MEMO

DATE: August 22, 2016
TO: Lawrence Badiner, Badiner Urban Planning Inc.
FROM: Joshua Switzky, Planning Department
RE: PPA Case No. 2015-015138PPA for 625 Mariposa Street

Preliminary Project Assessment

Date: August 22, 2016
Case No.: **2015-015138PPA**
Project Address: 625 Mariposa Street
Block/Lot: 3996/013
Zoning: UMU (Urban Mixed Use)
58-X Height and Bulk District
Area Plan: Eastern Neighborhoods Area (Central Waterfront)
Project Sponsor: Lawrence Badiner
(415) 865-9985
Staff Contact: John M. Francis – (415) 575-9147
john.francis@sfgov.org

Title: 625 Mariposa Street
Comments: Shadow Fan taken at 69' inclusive of the stair, elevator and roof terrace heights.
Printed: 15 June, 2016

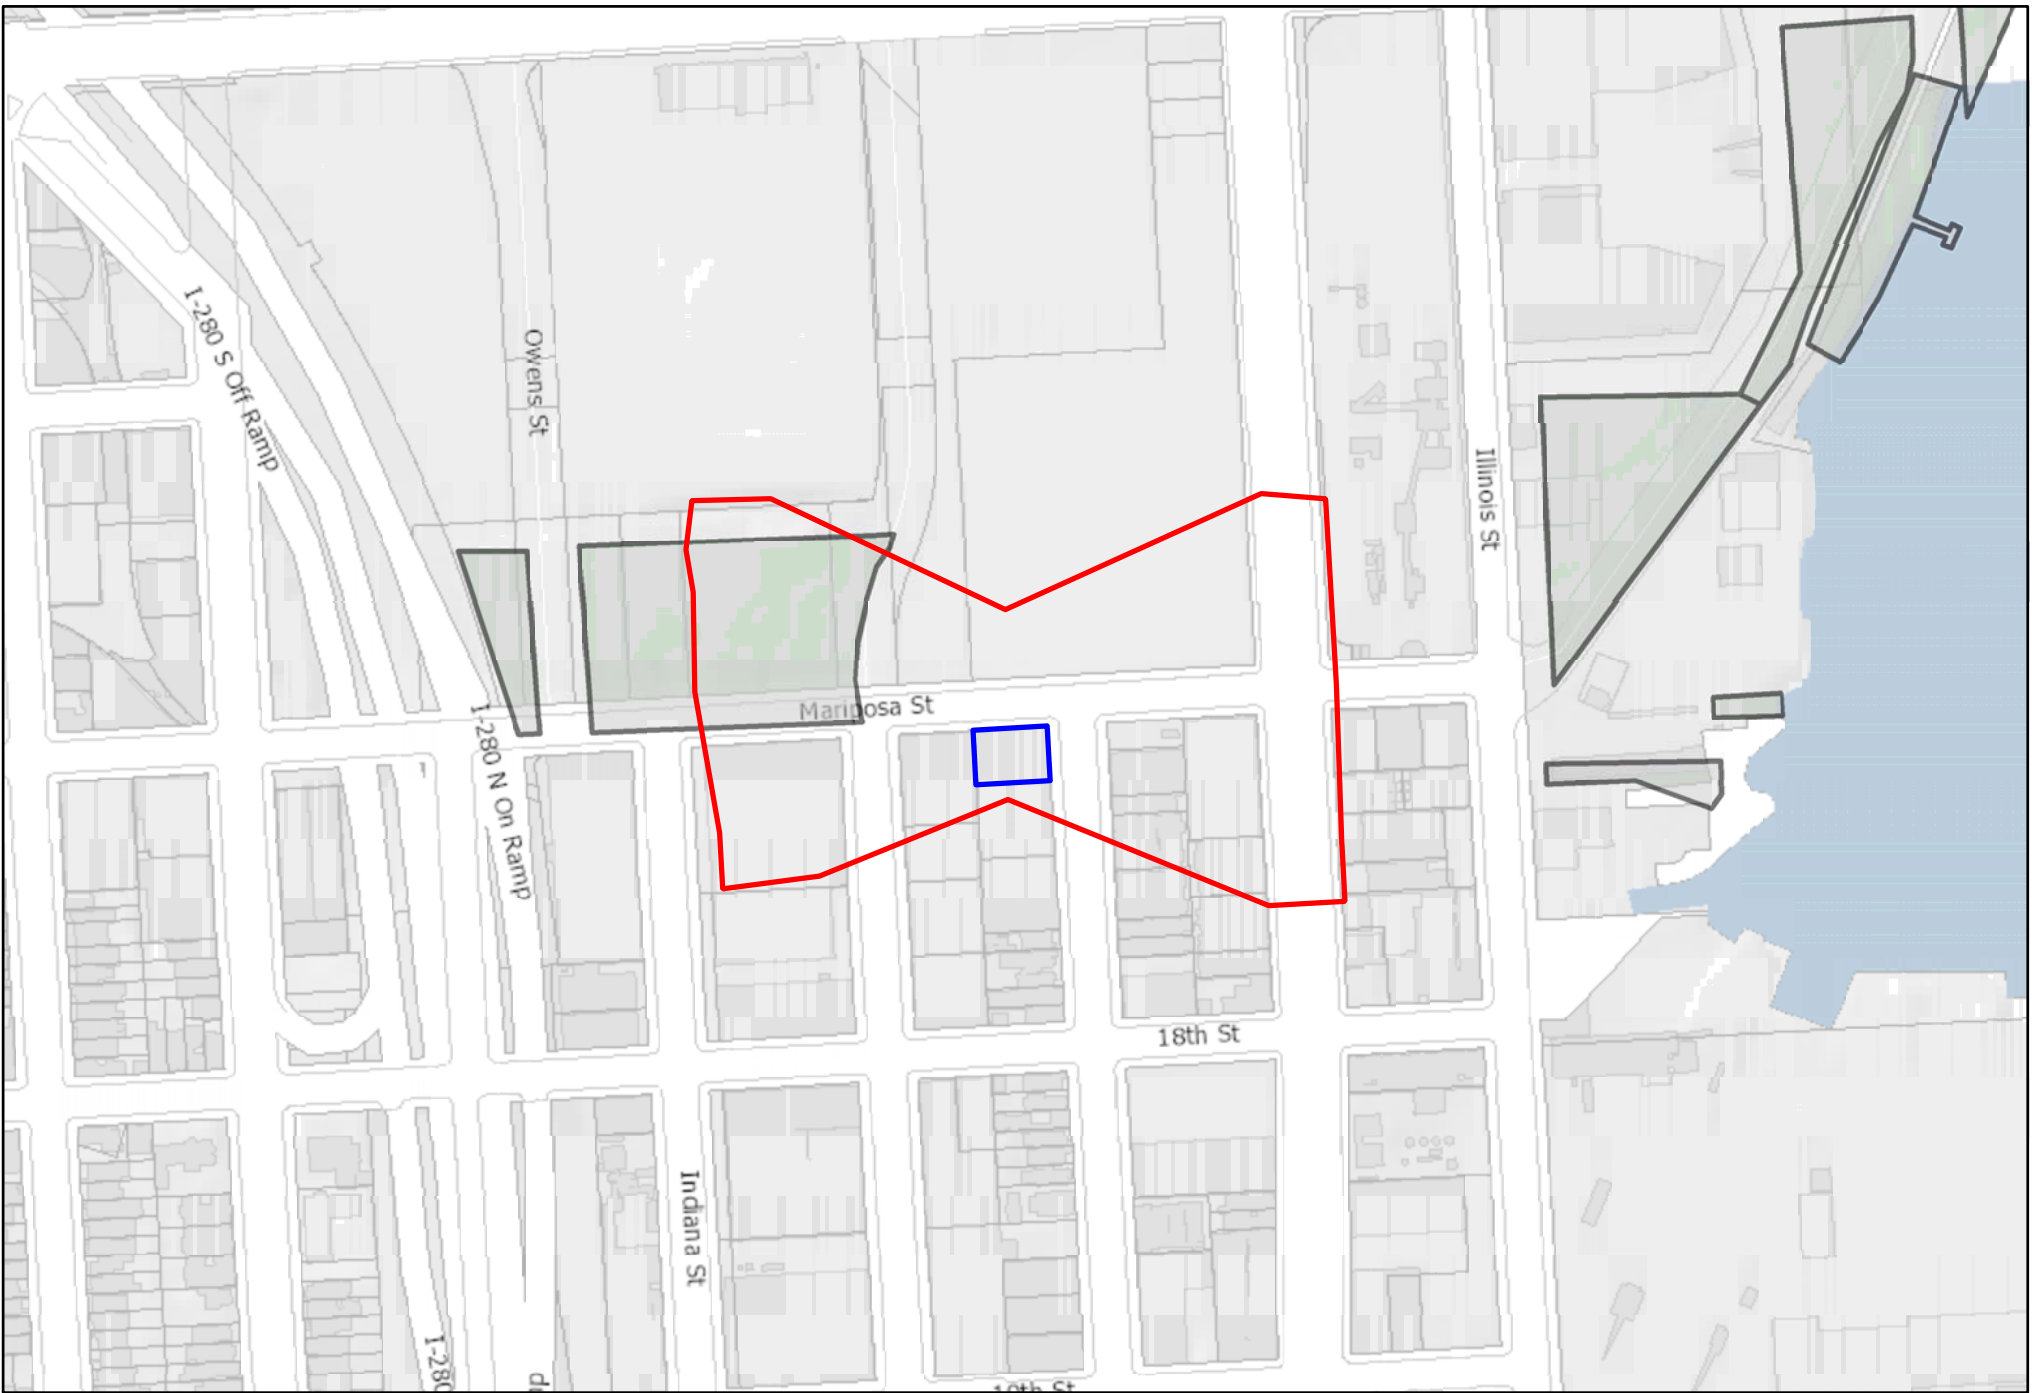
9. **Shadow Analysis.** A preliminary shadow study, at 75 feet to include the elevator and stair penthouse heights, was conducted by Staff in conjunction with this PPA Application, and it indicated that the project will not cast a shadow on any park or open space protected under Planning Code Section 295. However, Planning Code Section 147 also requires that new buildings and additions to existing buildings in the Eastern Neighborhoods Mixed Use Districts that exceed 50 feet shall be shaped to reduce substantial shadow impacts on public plazas and other publicly accessible spaces *other than those protected under Section 295*. The aforementioned shadow study indicates the project may cast new shadow on Mariposa Park, which is an existing city-owned public open space not under the jurisdiction of the Recreation and Park Department (i.e. not protected under Section 295). Therefore, pursuant to Section 147, a detailed shadow analysis would need to be prepared to determine if the project would create new shadow that results in an adverse impact to Mariposa Park.

If this detailed shadow analysis finds that the project would cast shadow on Mariposa Park, the Project Sponsor should explore sculpting portions of the project to avoid casting new shadows on the open space. Furthermore, for CEQA purposes, the analysis also determines whether a project has the potential to cast shadows on other parks and other spaces. The project sponsor is therefore required to hire a qualified consultant to prepare a detailed shadow study. The consultant must submit a Shadow Study Application, which can be found on the Planning Department's website (<http://www.sf-planning.org/Modules/ShowDocument.aspx?documentid=539>). A separate fee is required. The consultant must also prepare a proposed scope of work for review and approval by Environmental Planning staff prior to preparing the analysis.
